Access Compliance Report

Public Rights-of-Way

(Curb Ramps)

Intersection ID: 46698	Main Street: COFFEEBERRY_LN	Cross Street: TROTTERS_RIDGE_RD	Location: SW
ADA ID: 26BEAA7948D0	Ramp Type: PerpDiag	Initial Pass/Fail: Fail	Overall Compliance: No
Severity Score: 22.5			
Codes/Mitigation Info/Possible Solution		Field Measurements/Component Compliance

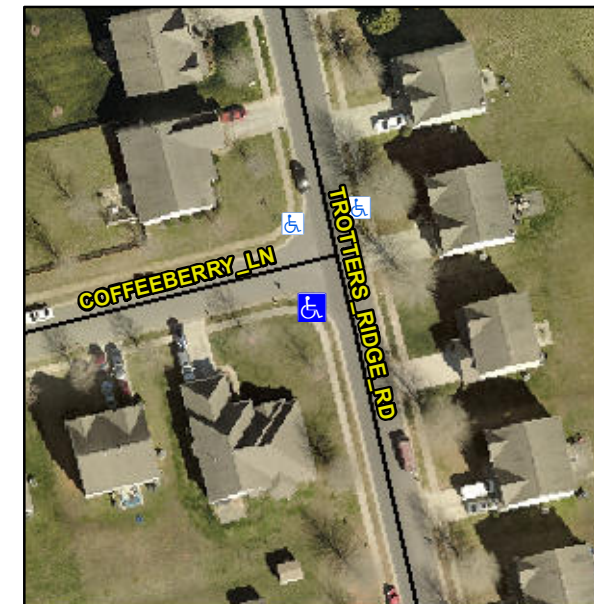
Not Found, R304.5.1, R304.2.2, R304.5.3

Compliance	Description	Data	Compliance	Description	Data
N/A	Ramp Length (in)	49.0	No	Ramp Slope (%)	8.7
No	Ramp Width (in)	46.0	No	Ramp XSlope (%)	2.6
N/A	Flare Type LT	N/A	N/A	Flare Type RT	N/A
N/A	Flare Slope LT (%)	N/A	N/A	Flare Slope RT (%)	N/A
N/A	Flare Traversable LT?	N/A	N/A	Flare Traversable RT?	N/A
N/A	Landing Length (in)	N/A	N/A	DWS Provided?	N/A
N/A	Landing Width (in)	N/A	N/A	DWS Contrast?	N/A
N/A	Landing Slope (%)	N/A	N/A	DWS Length (in)	N/A
N/A	Landing X Slope (%)	N/A	N/A	DWS Full Width?	N/A
N/A	Landing Curb? (Y/N)	N/A	N/A	DWS Offset (in)	N/A
N/A	Shared Landing?	N/A			
N/A	Gutter Ponding?	N/A	N/A	Gutter Slope (%)	N/A
N/A	Gutter Lip Ht (in)	N/A	N/A	Gutter X Slope (%)	N/A
N/A	Painted X Walk1?	No	N/A	Painted X Walk2?	No
	X Walk 1 Direction	To E		X Walk 2 Direction	To N
N/A	X Walk 1 Width (in)	N/A	N/A	X Walk 2 Width (in)	N/A
	X Walk 1 Slope (%)	3.3		X Walk 2 Slope (%)	1.1
	X Walk 1 X Slope (%)	2.0		X Walk 2 X Slope (%)	3.1

Remove & Replace Curb Ramp With Two New Directional Ramps or Equivalent.
